MOUNTAIN'S EDGE

PCD File No. SF201

FINAL PLAT
MOUNTAIN'S EDGE

Sheet: 1 of 2

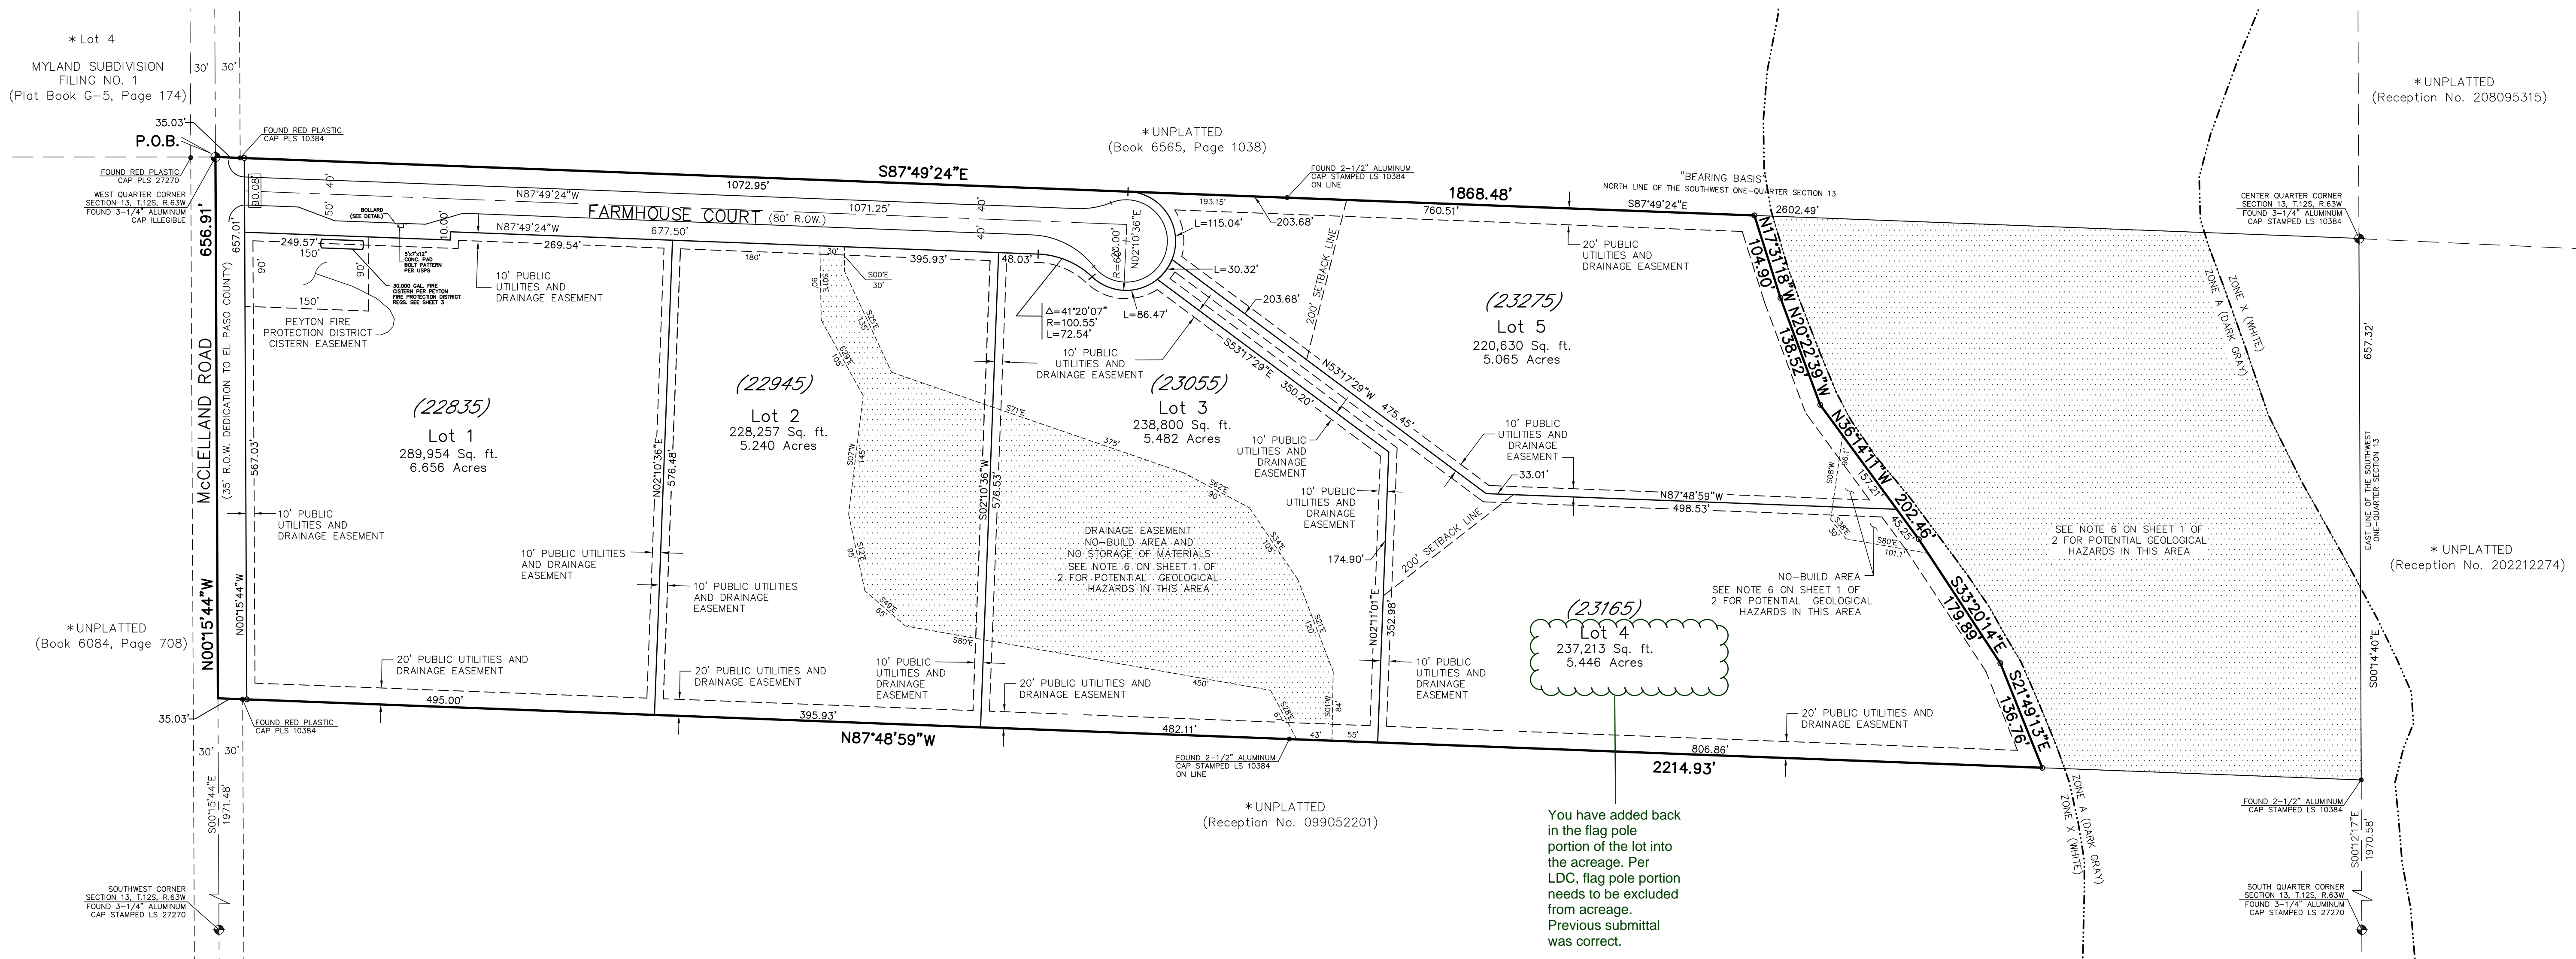
Filing No. 1 was removed from this title block. Please add it back in and replace all instances of "Mountains Edge" in this document with "Mountains Edge Filing No. 1"

These two notes should be combined.

Third time making this comment: Identify which lots need engineered foundations and septic systems, per soils & geology report.

Previous comment note addressed: This is already included within Note 6. Incorporate this additional information into that note.

Project No.: **08019**
Sheet: **2** of **2**

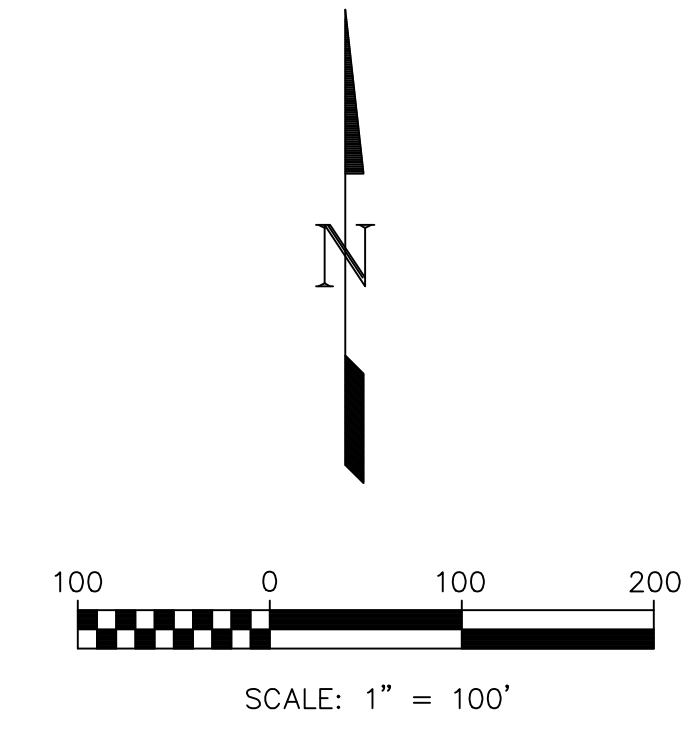
You have added back
in the flag pole
portion of the lot into
the acreage. Per
LDC, flag pole portion
needs to be excluded
from acreage.
Previous submittal
was correct.
